UNITED STATES OF AMERICA
NUCLEAR REGULATORY COMMISSION

In the Matter of)	
)	
CAROLINA POWER & LIGHT COMPANY)	
AND NORTH CAROLINA EASTERN MUNICIPAL)	Docket Nos. 50-400 OL
POWER AGENCY)	50-401 OL
(Shearon Harris Nuclear Power Plant,)	
Units 1 & 2))

APPLICANTS' RESPONSES TO RICHARD WILSON'S
INTERROGATORIES ON CONTENTION IVC (SECOND SET)

PLANT LIQUID EFFLUENT

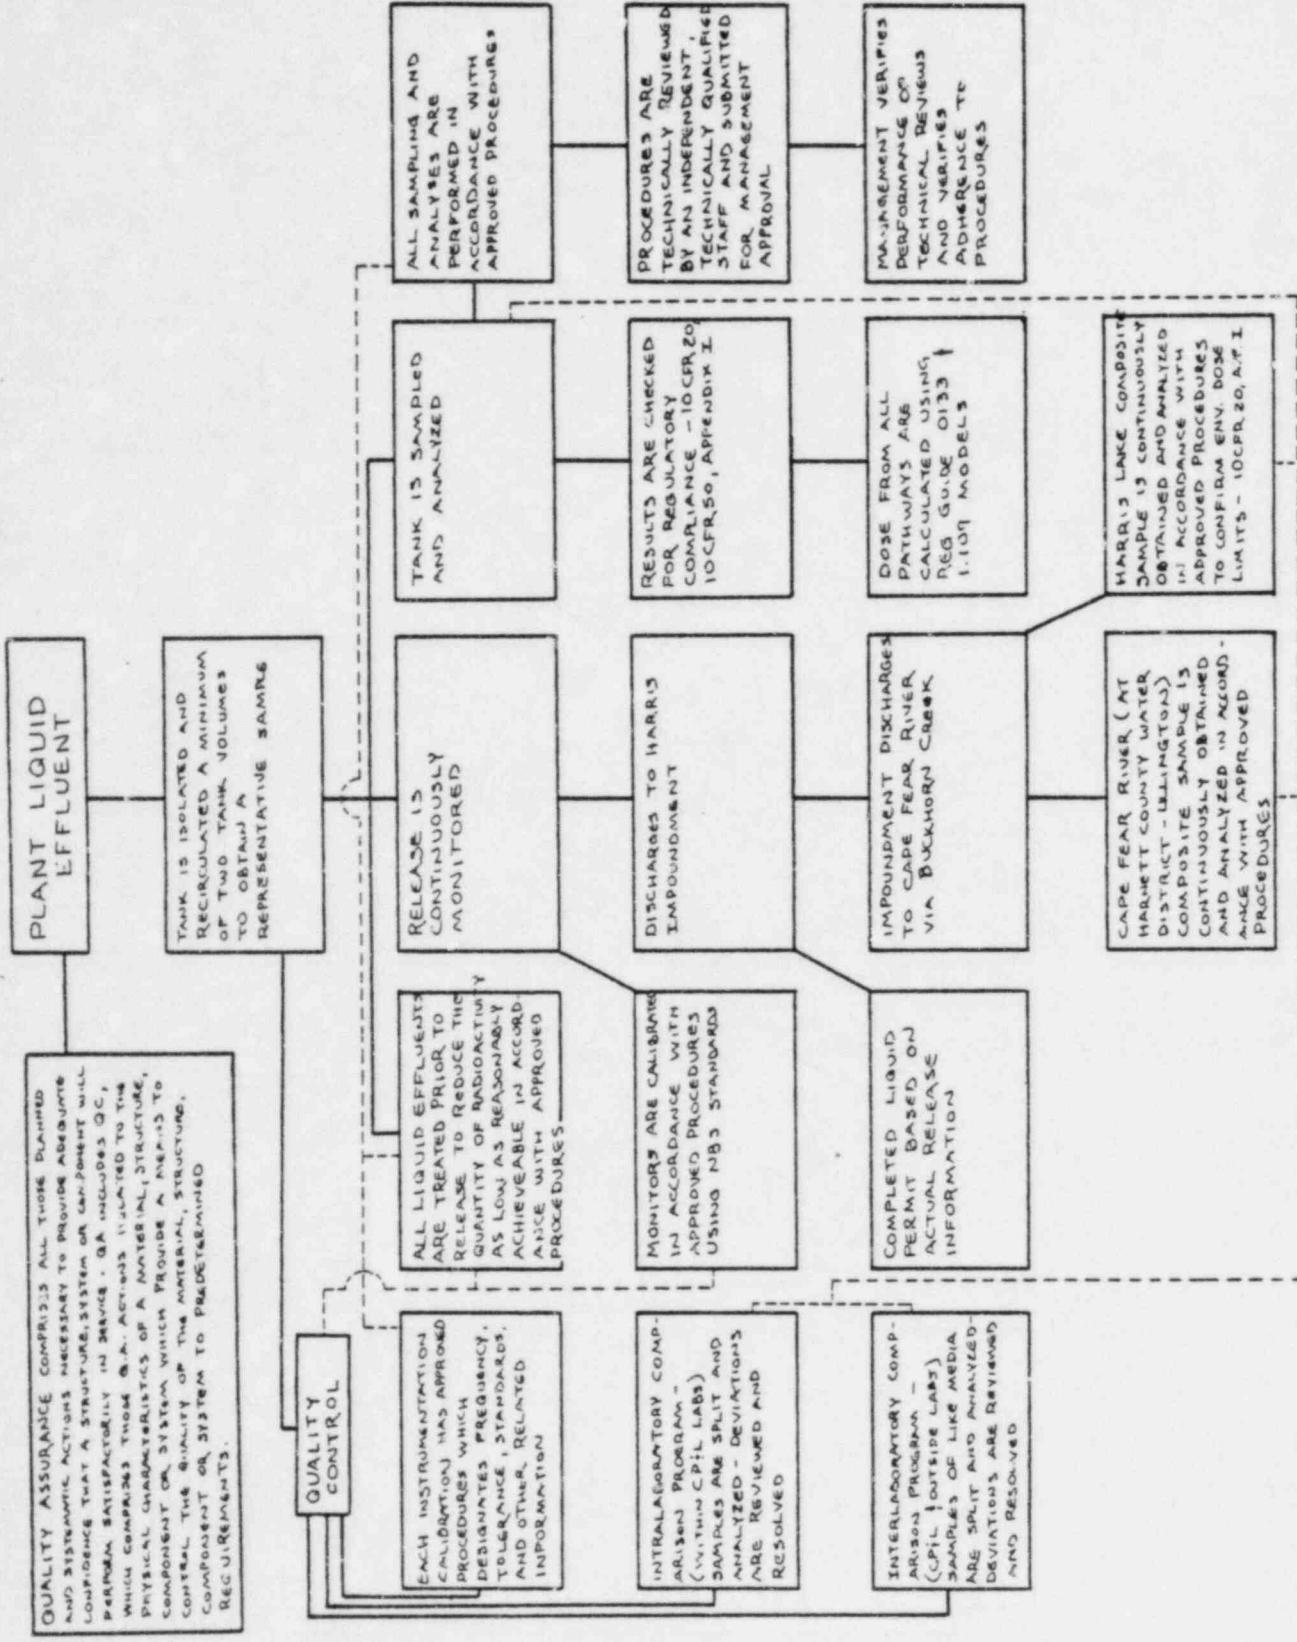
(4). Please illustrate a particular sampling pathway in detail, examining the precise method of control measurement, the systematic nature of sampling times, and the effects of inclement weather, etc. on the collection process.

ANSWER NO. IVC-2(4). See attached chart.

This chart was prepared by Don H. Edwards, Jr.; Senior Specialist - Environmental; Carolina Power & Light.
